Meeting Agenda Plat Committee

Monday, November 29, 2021

1. [KPB-3725](#) Catkin Subdivision 2021 Replat; KPB File 2021-144

KPB 2021-144
S26 T05S R12W
FRITZ CREEK

DRAWN BY: SCS DATE: OCTOBER 2019 SCALE: 1" = 100'
CHK BY: SCS JOB #19-19 SHEET 1 OF 1

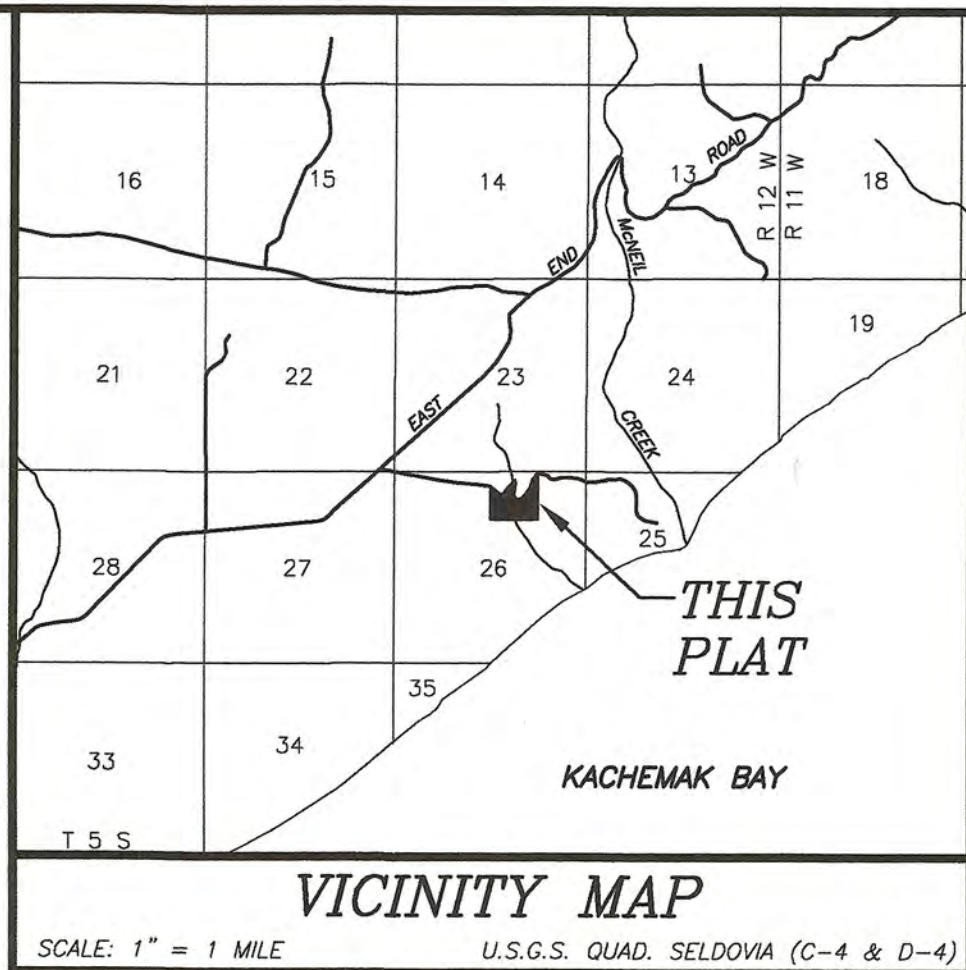
This plat is proposing to dedicate a 30 foot wide right of way along the western boundary. The lot to the west, Tract D-2, is 23 acres and could be further subdivided and provide a matching dedication. The southern portion of the proposed dedication appears to encompass a portion of the private travel way. As the private road goes north, it veers to the east and outside the proposed dedication. The private travel way is not required to be shown on the final plat but if it is chosen to be shown, **Staff recommends** that a plat note be added clarifying the type and intended use.

Due to the steep terrain in the area and near the dedication of Guffers Road, a slope easement was granted on the parent plat. **Staff recommends** that this easement be carried forward and depicted on the plat. Additionally a plat note should be added explaining the uses of the slope easement.

A soils report will be required for Tracts B-2 and B-3 and an engineer will sign the final plat. Tract B-1 is larger than 200,000 sq. ft. and a soils analysis report is not required. **Staff recommends** the wastewater disposal note for Tract B-1 be revised by removing "or nominal 5 acres."

Platting Staff Comments: A soils analysis report will be required for Tract B-2 and Tract B-3. An engineer will need to sign the plat. A soils analysis report is not required for Tract B-1. The wastewater note for Tract B-1 needs to be revised by removing “or nominal 5 acres”.

KPB 2021-021R1

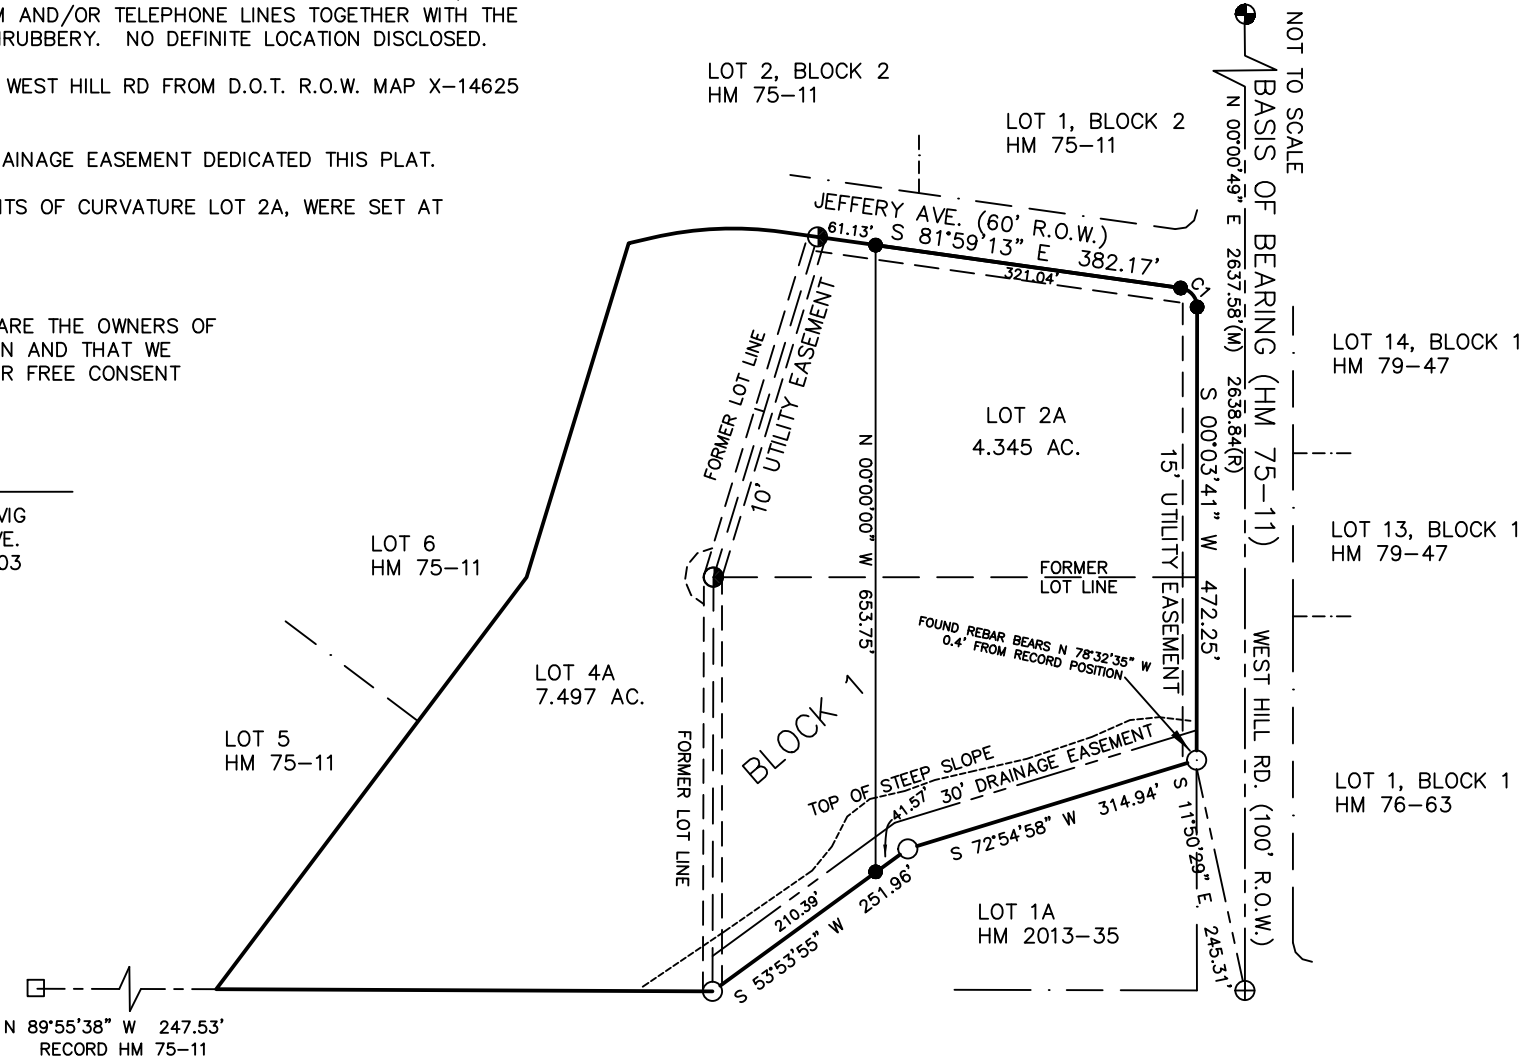
Utility Easements The City of Homer requested the utility easements along the right of way be increased to 15 feet from the previously granted 10 feet. The plat depicts and notes the 15 foot utility easements. A 20 foot utility easement was also granted by the parent plat centered on the shared lot line between Lot 4 and Lots 3 and 2. A 30' radius anchor easement was also granted. These easements are depicted but the labeling should be revised to make the depiction easier to understand. **Staff recommends** the anchor easement be labeled and noted either in the label or plat note that it was granted by HM 75-11. The former lot line labels should clearly point to the line or add the line style to the legend. The depiction of the 15 foot utility easement should be continued west within Lot 4A.

- Add "R1" to the KPB File number.
- Add a space between "Meridian," and "within".

Staff recommendation: The parent plat depicted a building setback. Provide a plat note stating, "Per KPB 20.30.250 the building setback of record has been removed. All development must comply with the municipal zoning requirements."

Staff recommendation: An acceptance for the drainage easements is present. Make "easement" plural and correct the spelling of "Governing".

*Correct the spelling of "drainage" within plat note 8.
Update the wastewater notes as required to comply.*

PRELIMINARY PLAT

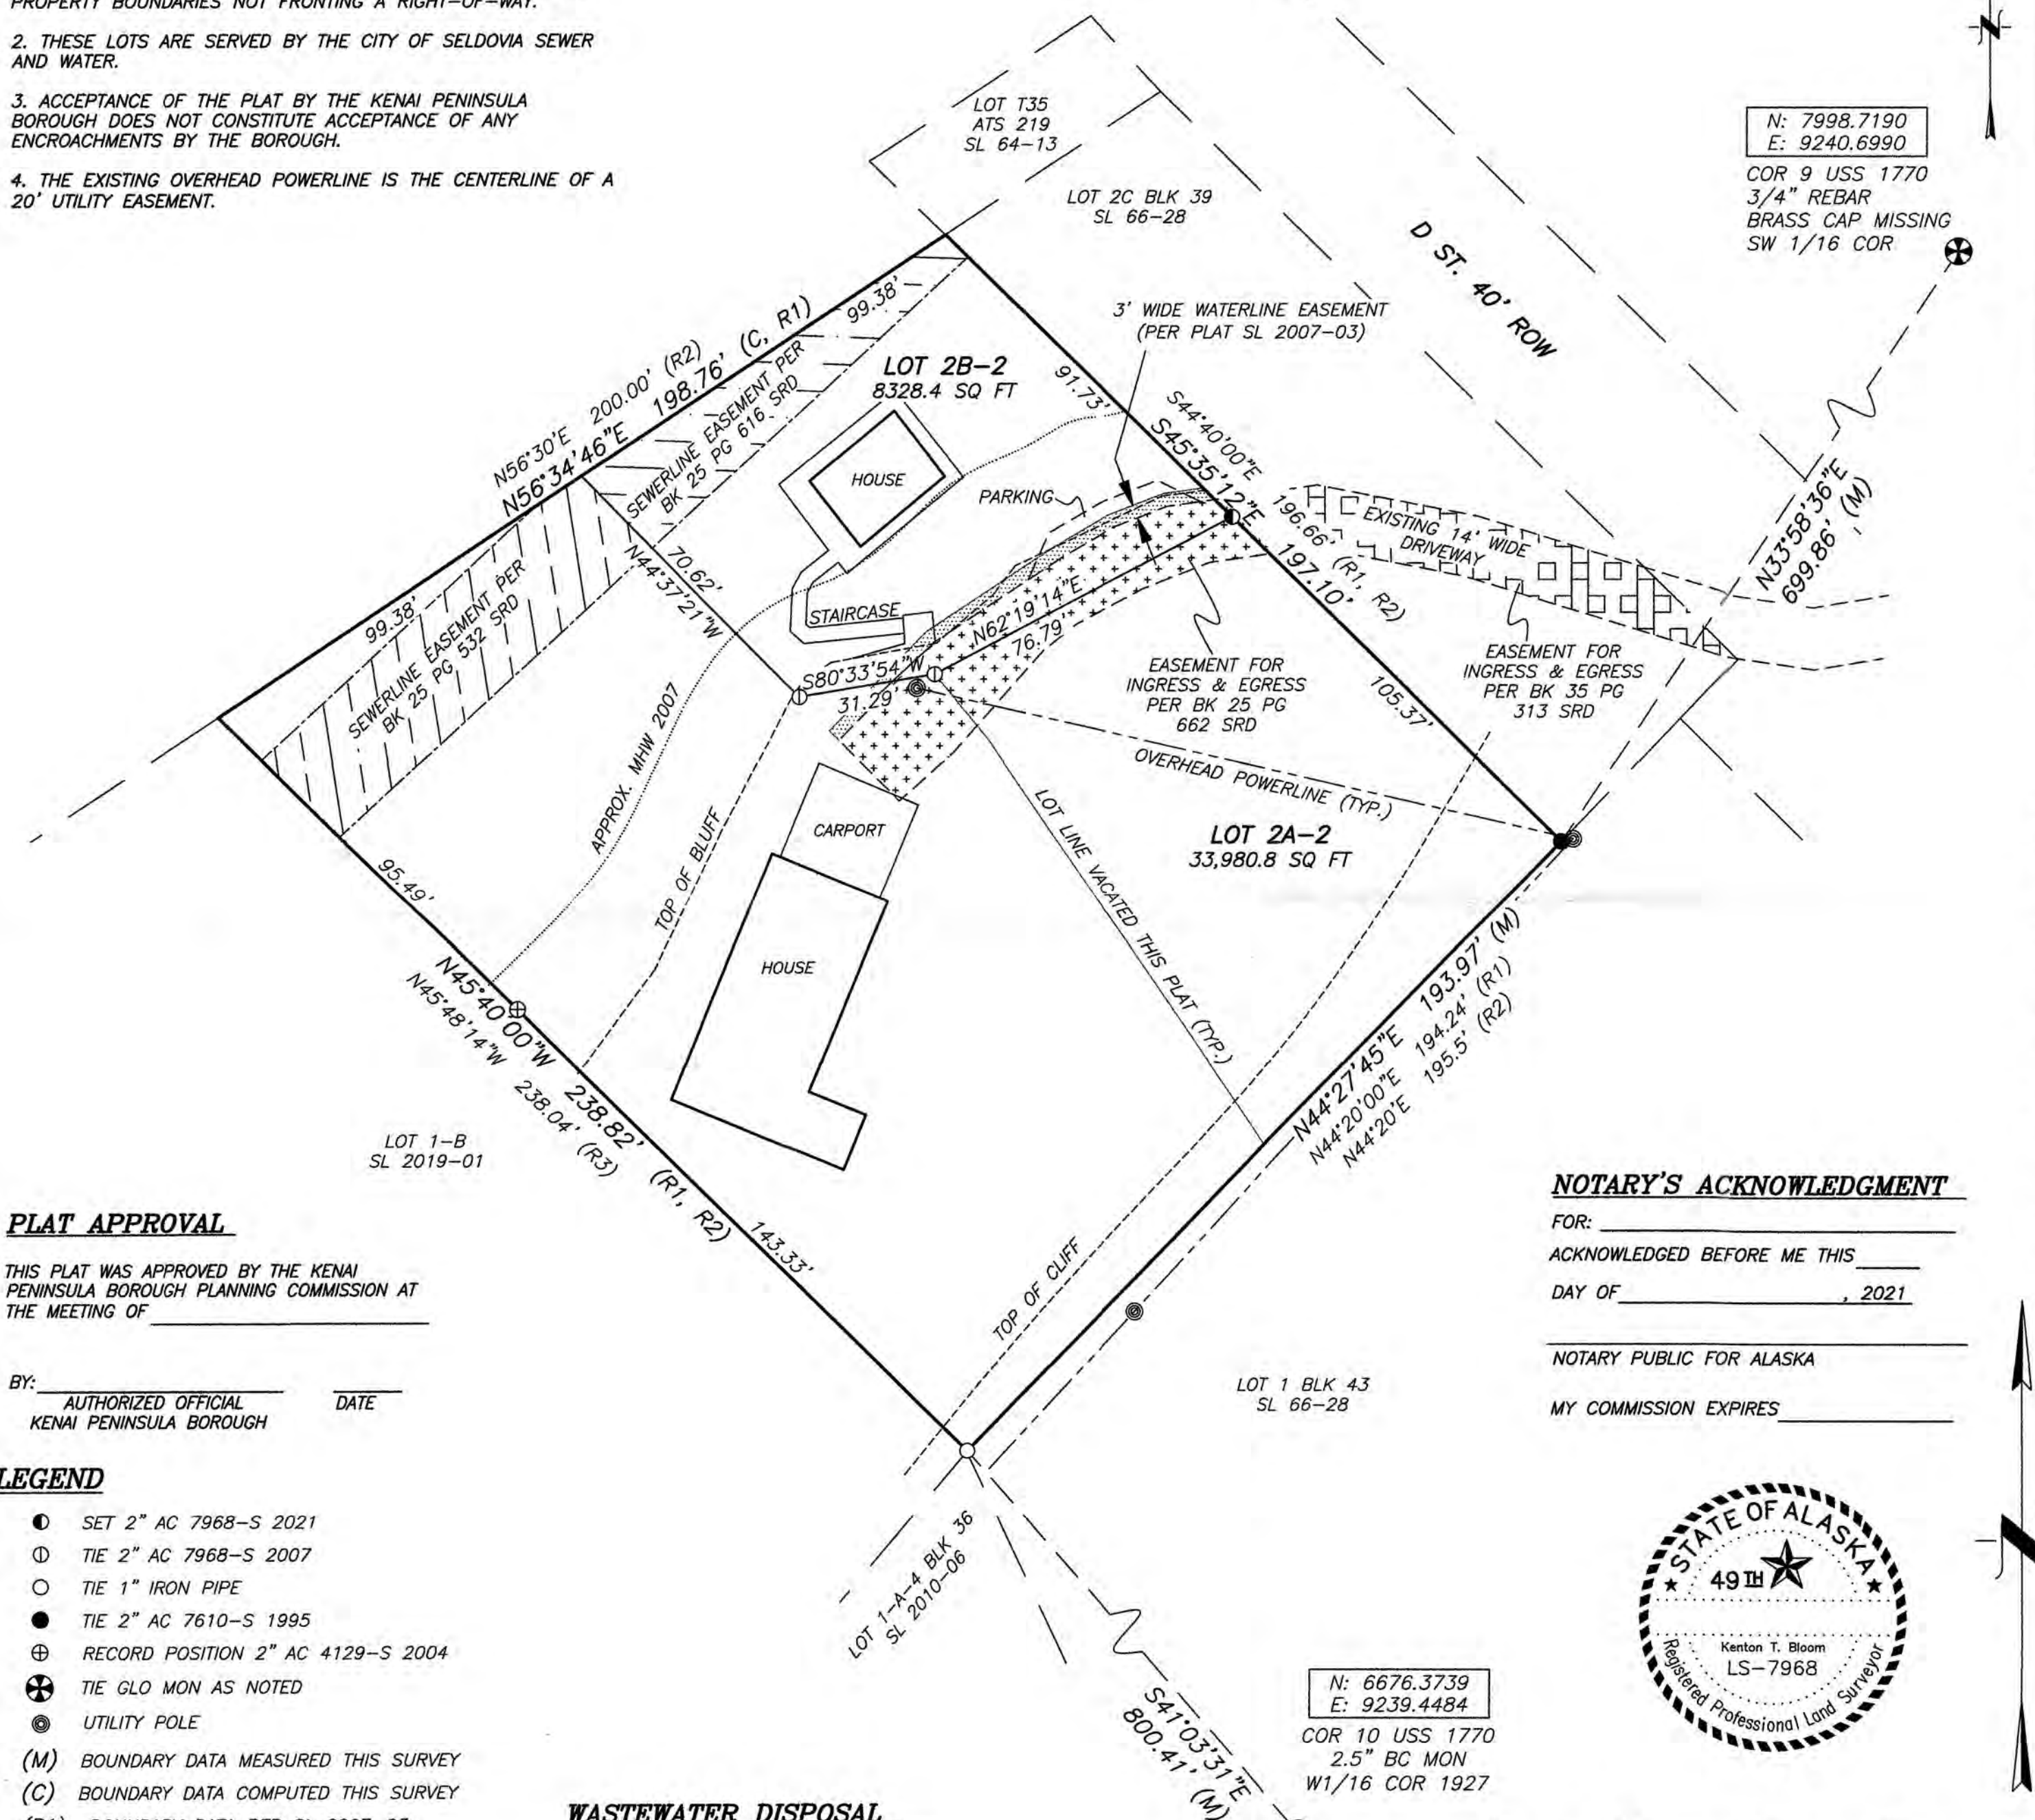
Portions of the subdivision are within Flood Zone A. ***Staff recommends the flood line be depicted and the appropriate notes be added to the plat.***
